Please find my response regarding the unsafe and unbuildable roof access and the proposed cycle and bin stores.

Request for Actions and Application Status

[Extract from the applicant's proposed plan CF-214-DR-1130-C (3rd version) - showing illogical levels]

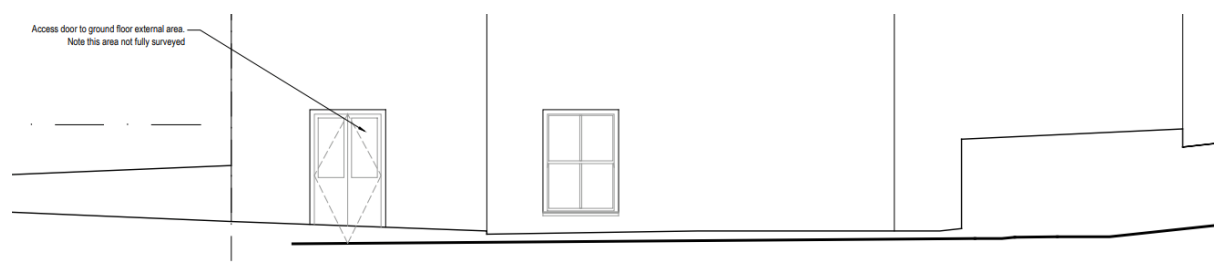
Thank you for the revised elevation F-214-DR-1310-C. However, this drawing, even after three versions, remains incorrect and contradicts the finished floor levels as shown on the proposed plan CF-214-DR-1130-C. An accurate drawing would show the roof access as only one metre tall, rendering it unsafe and unbuildable.

- The third version of the proposed plan (CF-214-DR-1130-C) shows the internal roof access landing at the same level as Flat 9 (+11.330), with no indicated level change to the external landing.
- However, the same plan inconsistently shows the external landing at +10.921, which is a factual impossibility if both landings are at +11.330.
- Consequently, an accurate elevation drawing based on the plan would result in a roof access door just over one metre tall, rendering it inaccessible and unsafe.

To conclude, please compel the applicant to provide logical and buildable design drawings for roof access and safe regular maintenance provision. Please compel the applicant to provide accurate and realistic existing drawings for the front and rear gardens, and what changes to them are actually being proposed before assessing their acceptability against planning policies.

Diagram 17 Flue outlet positions for solid fuel appliances

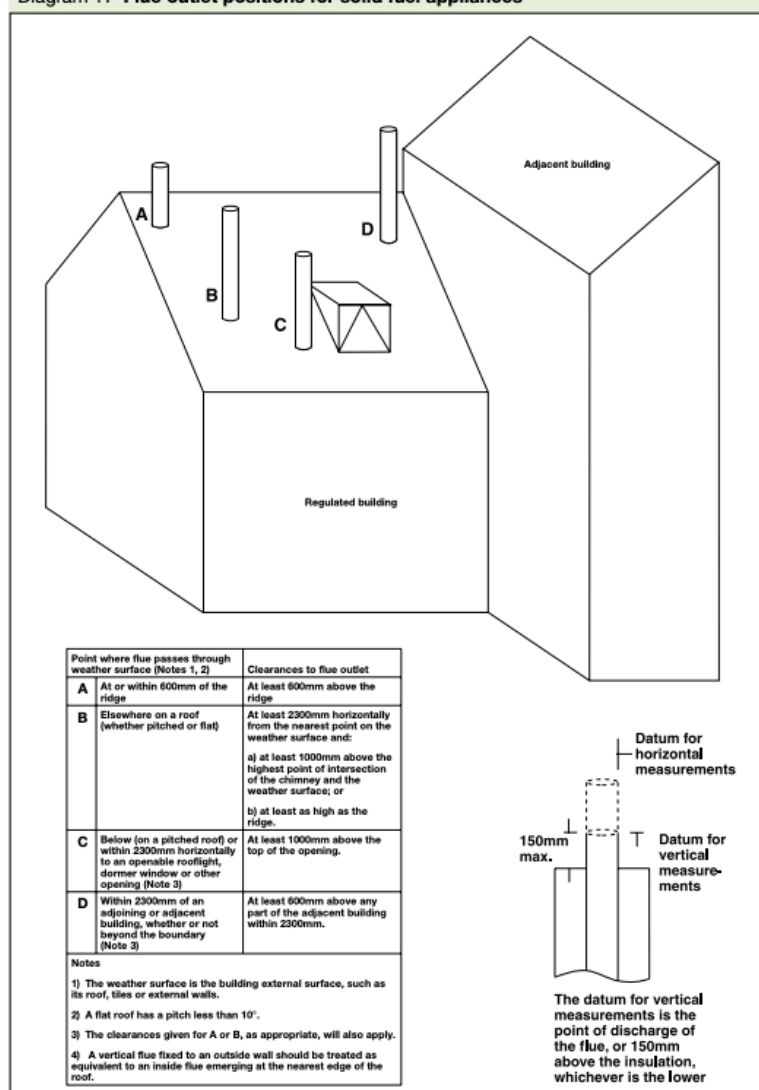
My primary concern, which remains unaddressed, is the unsafe non-compliance with Building Regulations Approved Document Part J, Diagram 17, regarding the safe location of flue openings near other structures (not just windows). I struggle to understand why the requirement for flue openings to maintain a minimum horizontal clearance of 2.3 metres **from any part of an**

adjacent building is being ignored by the applicant's architects. Flues shielded by or too close to walls and below the ridge line are unsafe for those using the combustion devices. That is why it is normal for chimneys to terminate above the ridgeline, not below it or next to a wall. In the current design, the flue openings are significantly closer to the new structure than this required distance. I refer to the previously submitted image from my objection letter:

To comply with the regulations, the chimneys must be extended upwards to be 600mm above the ridge, or the proposed rooftop extension's eastern flank wall must be set back significantly from the flues. It is crucial that no part of the new structure is within 2.3 metres horizontally of the flue openings. In addition, there are multiple flue openings across the roof structure, not just the eastern flank that fail this safety regulation. These flues will need to be made taller to be compliant, and this has not yet been addressed. As you can appreciate, making the chimney design safe and compliant will have a major visual and spatial impact and must be addressed before determination, not through conditions.
